ADDENDUM No. 2

March 30, 2016

Little Sisters of the Poor Main Street Renovations
601 Maiden Choice Lane, Baltimore MD 21228

Project No: 15046.00

P-610

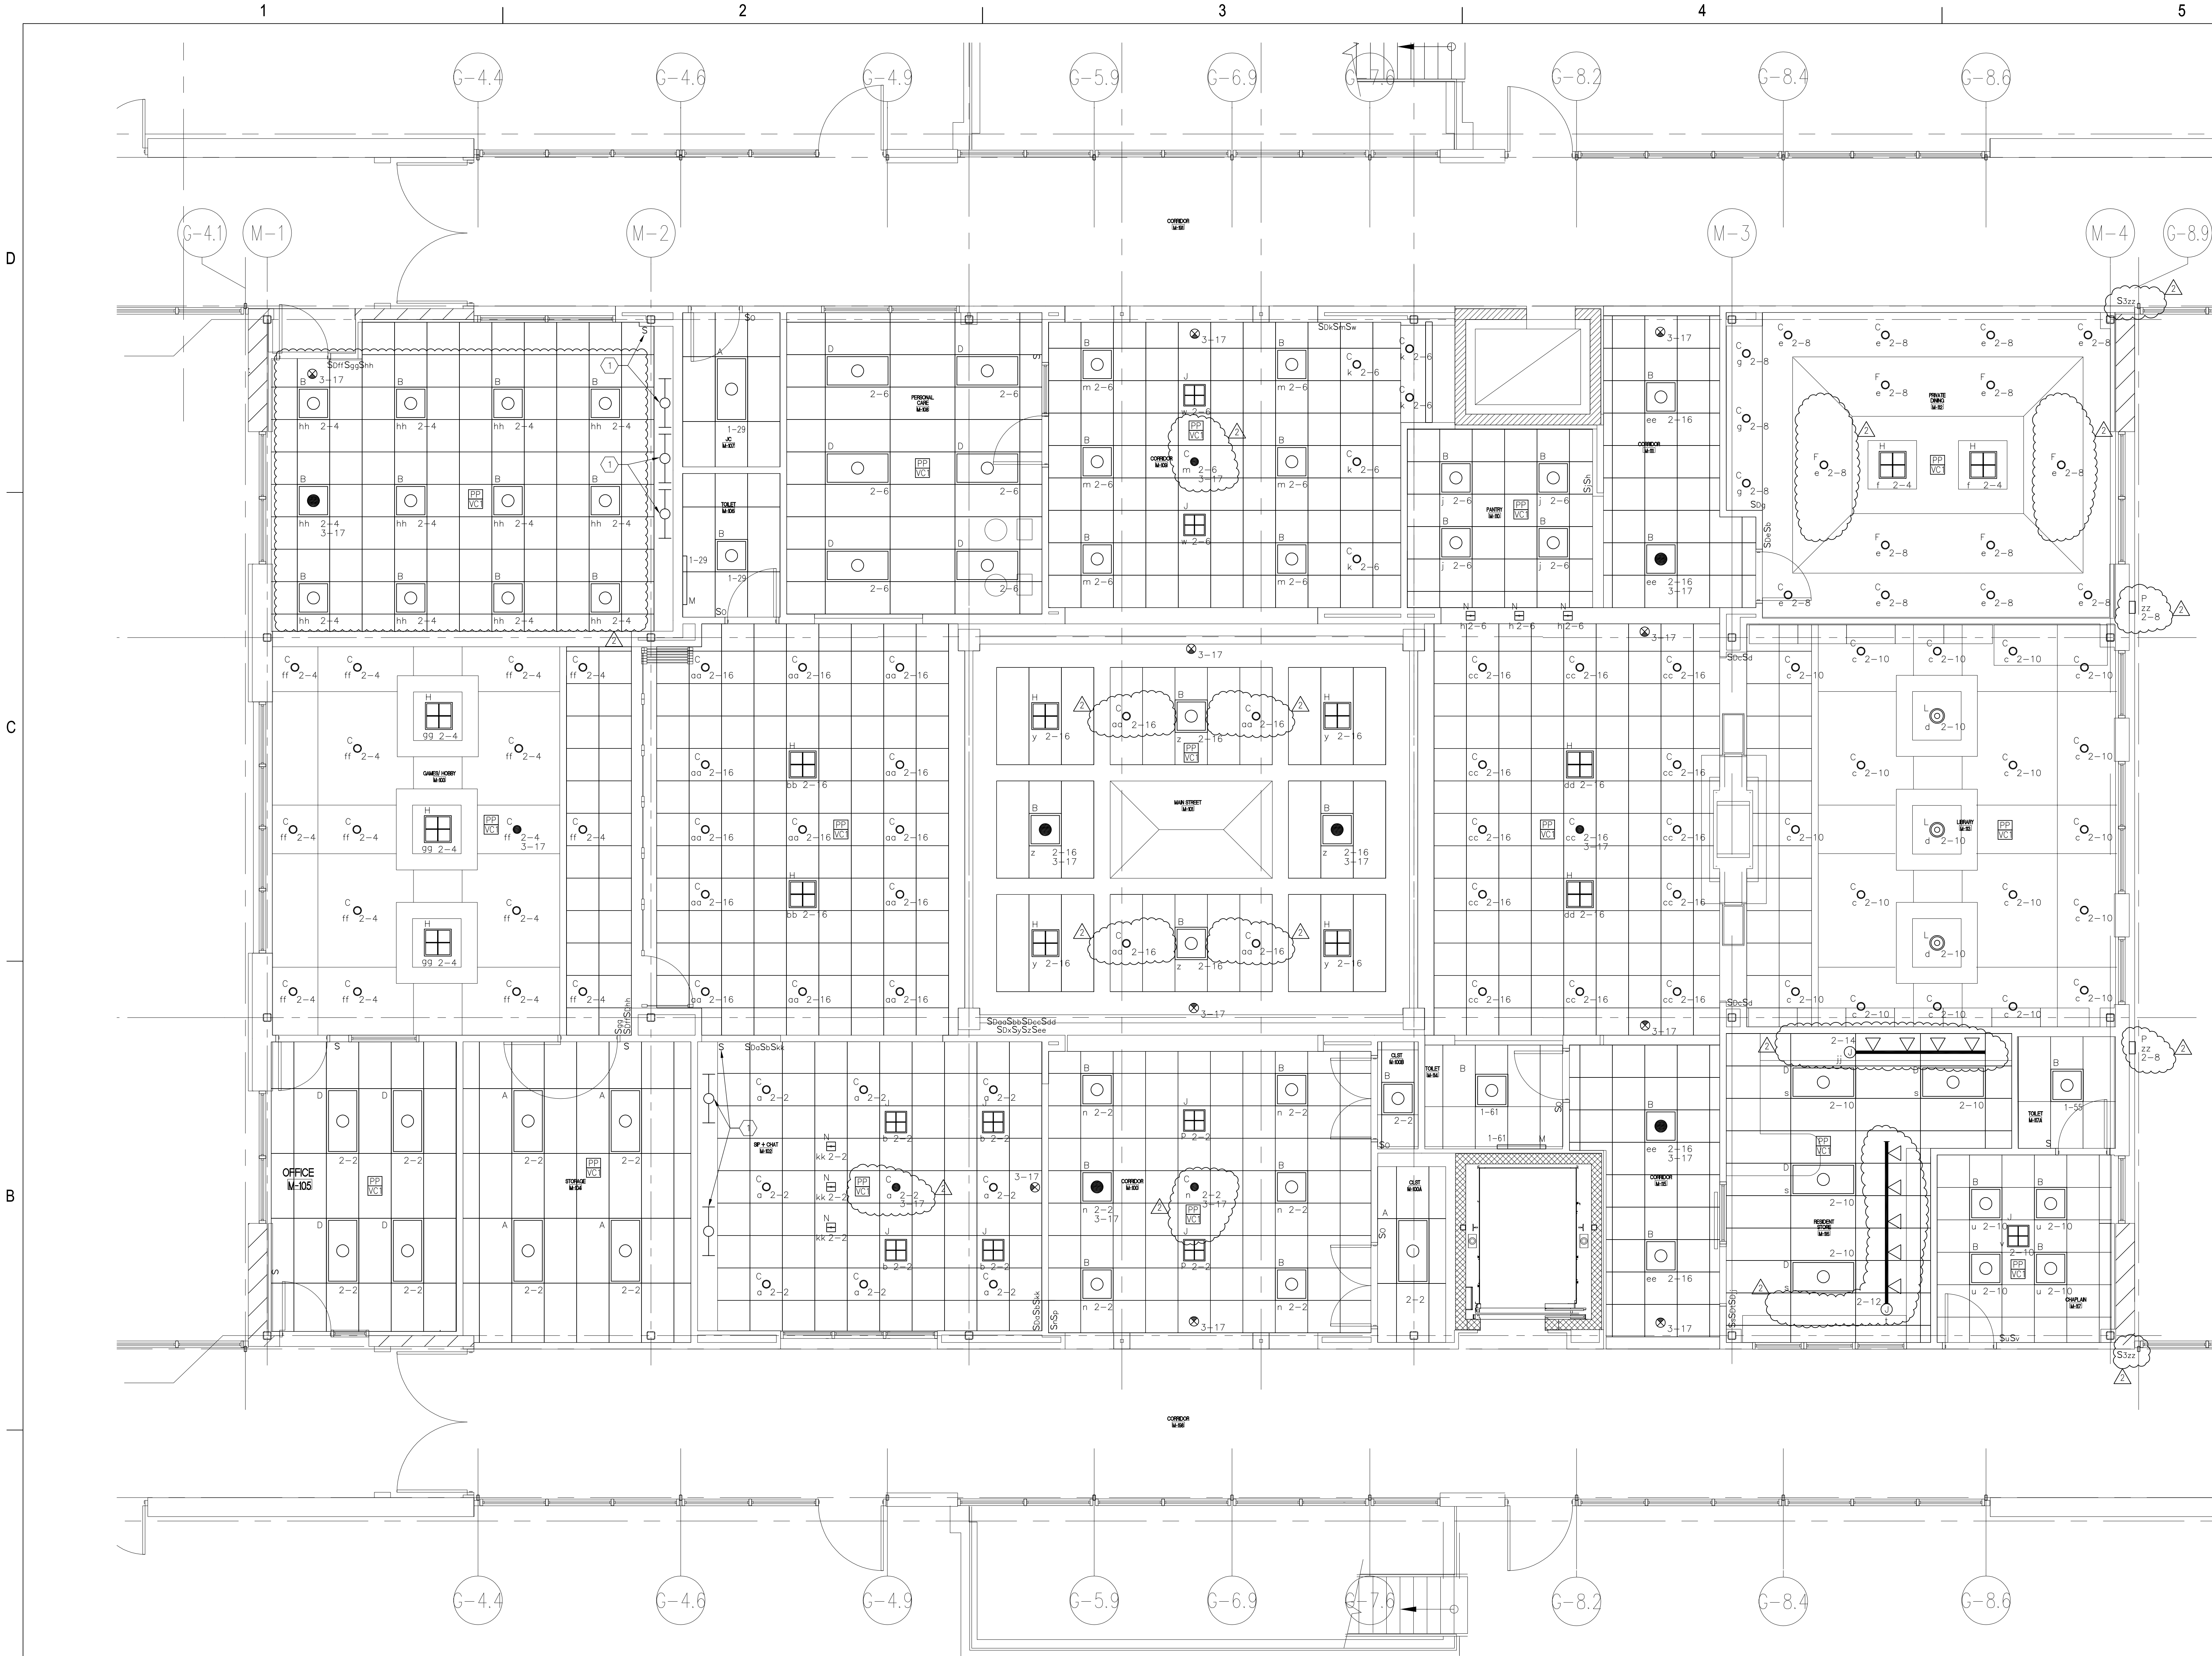
1. Section 220500 Common Work for Plumbing:
 - a. Article 2.2.G: Add P-11 Coffee Maker
 - b. Article 2.2.G: Revise P-8, P-9, P-11 basis of design to "Gray Guy Box"

P-10	HAIR SALON SINK	1-1/2"	-	1-1/2"	1/2"	1/2"	PROVIDED UNDER ANOTHER DIVISION			1,2
P-11	COFFEE MAKER	-	-	-	1/2"	-	PROVIDED UNDER ANOTHER DIVISION	GUY GRAY BOX: BIM875		1,2

E-311

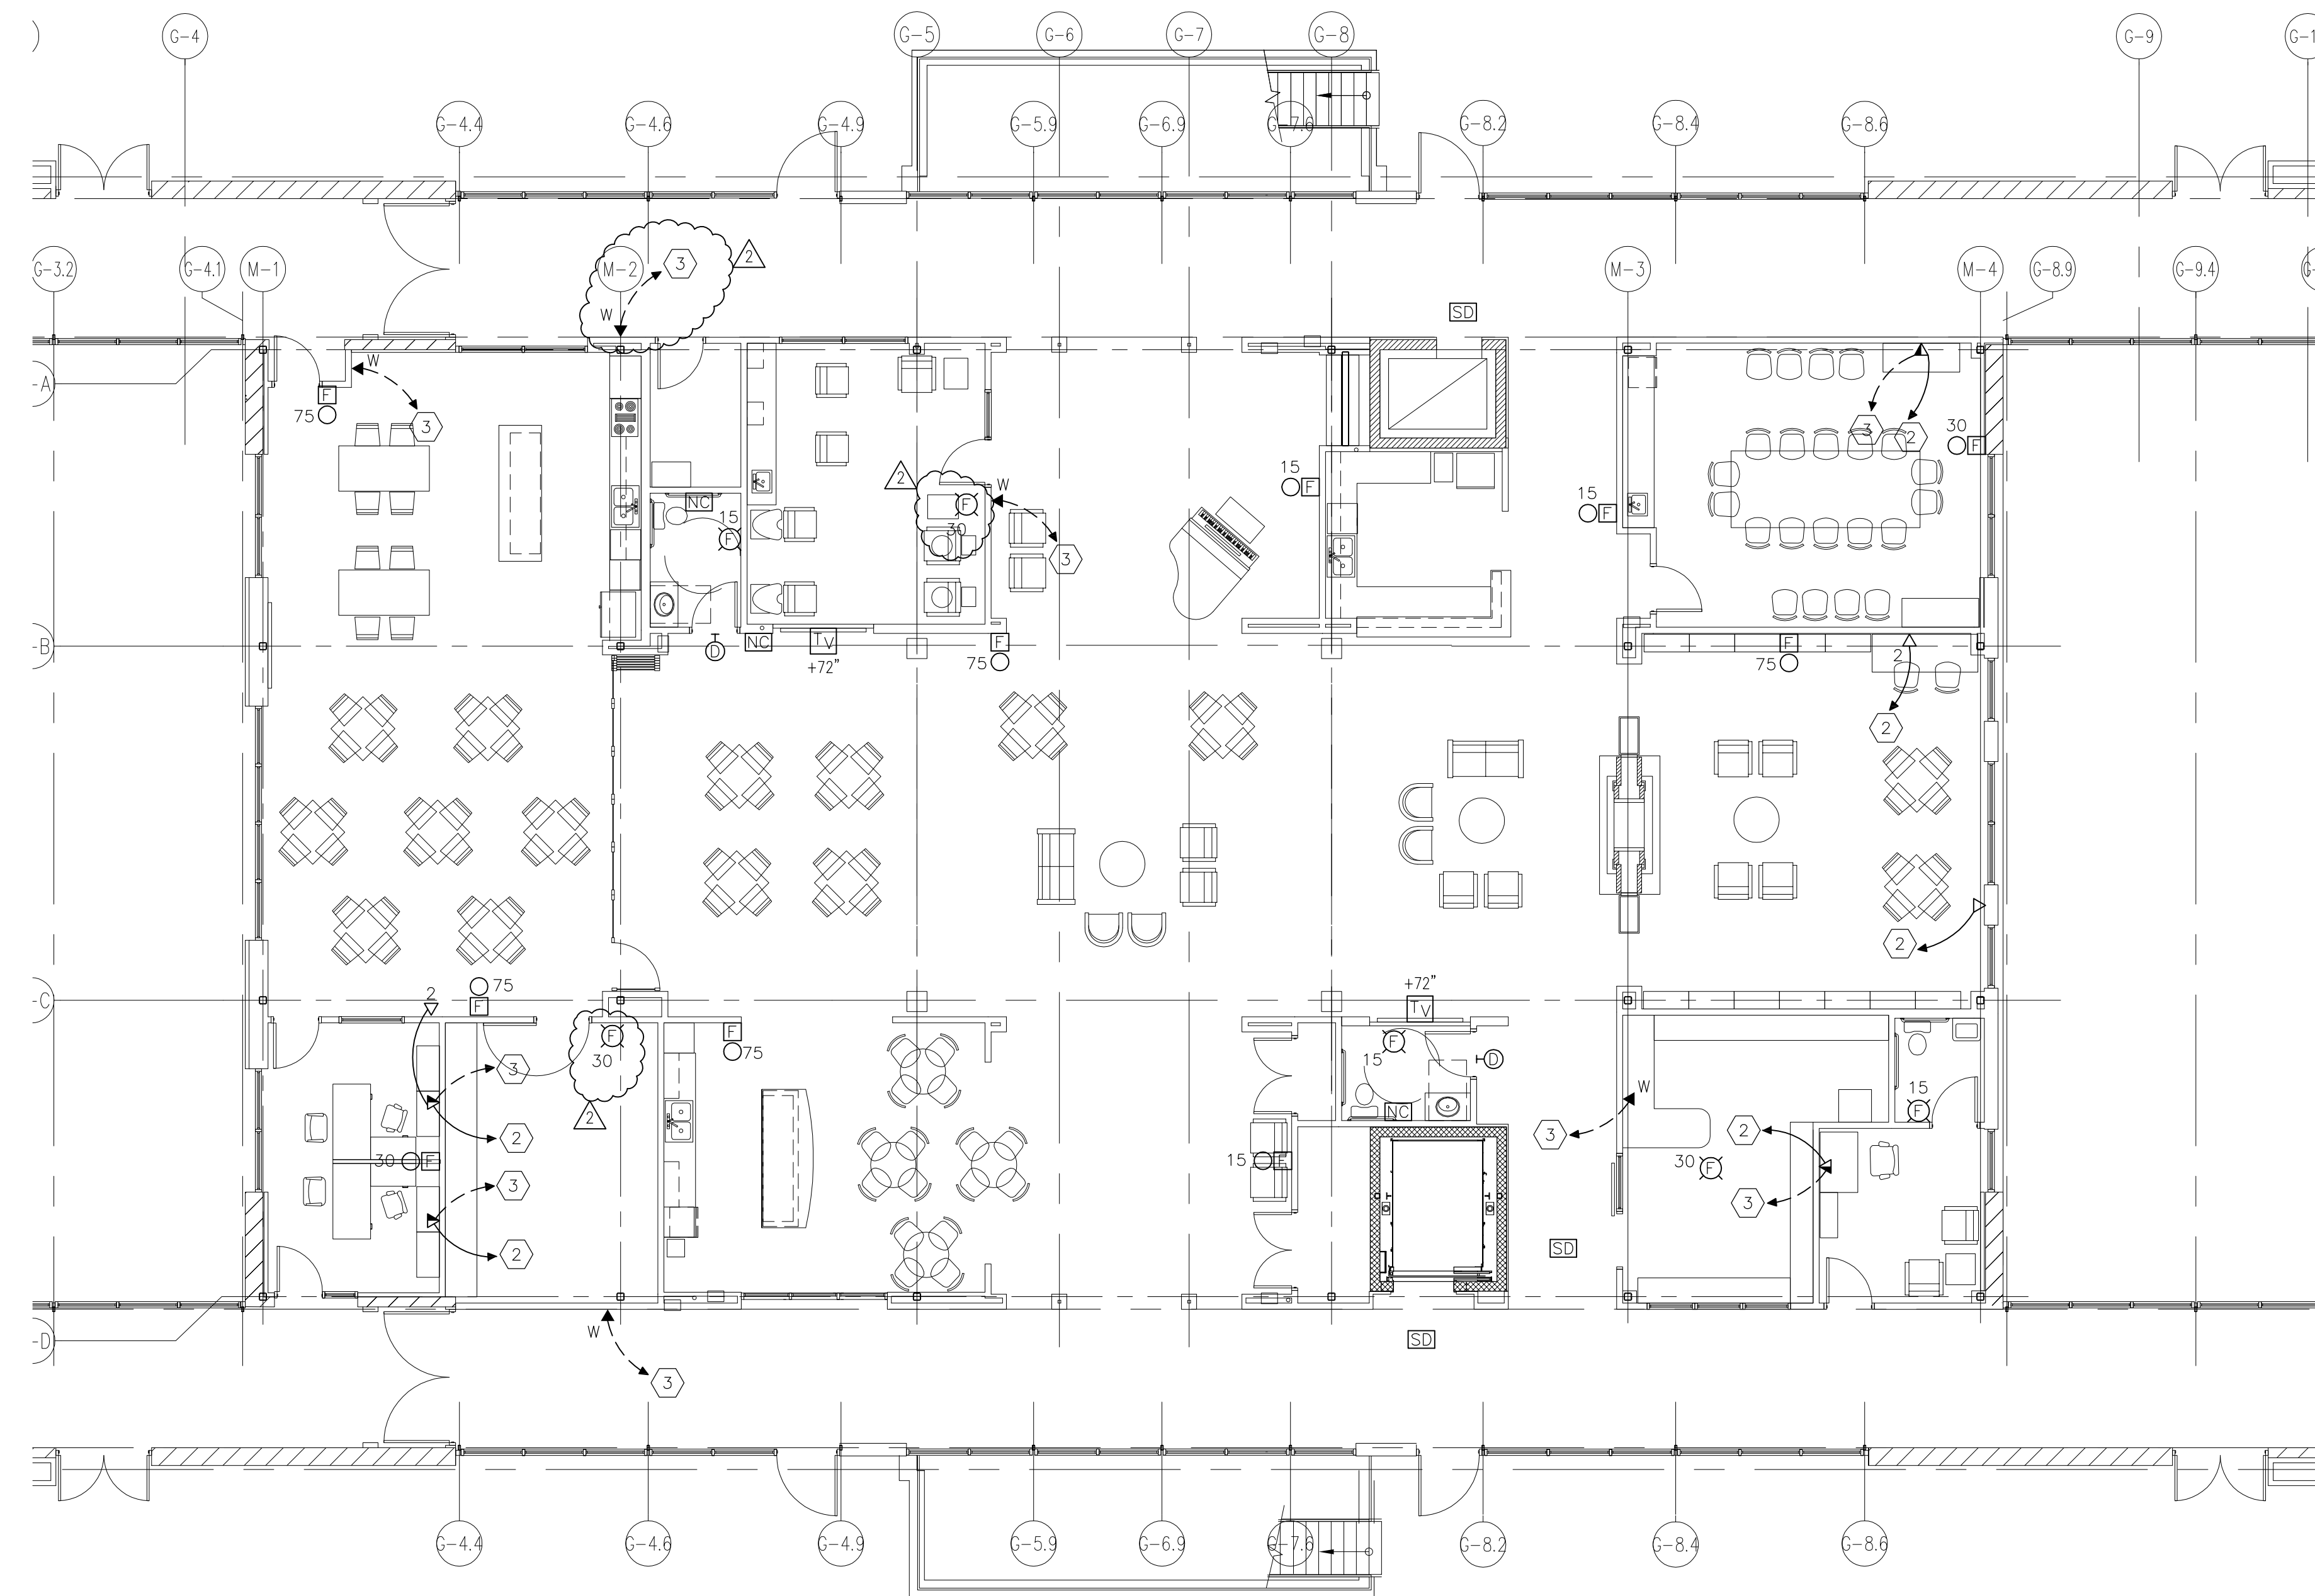
1. Drawing E-111: see attached sketch E-SK-111-01 for added floor receptacle in Main Street M-101.
2. Drawing E-211: see revised drawing for:
 - a. Updated lighting in rooms M-100, M-101, M-102, M-103, M-109, M-112 & M-116.
 - b. Added exterior lighting.
3. Drawing E-311: see revised drawing for:
 - a. Additional fire alarm devices in M-104 & M-108.
 - b. Additional telephone in north corridor.
- c. Drawing E-601: see attached sketch E-SK-601-01 for modifications to the lighting fixture schedule.
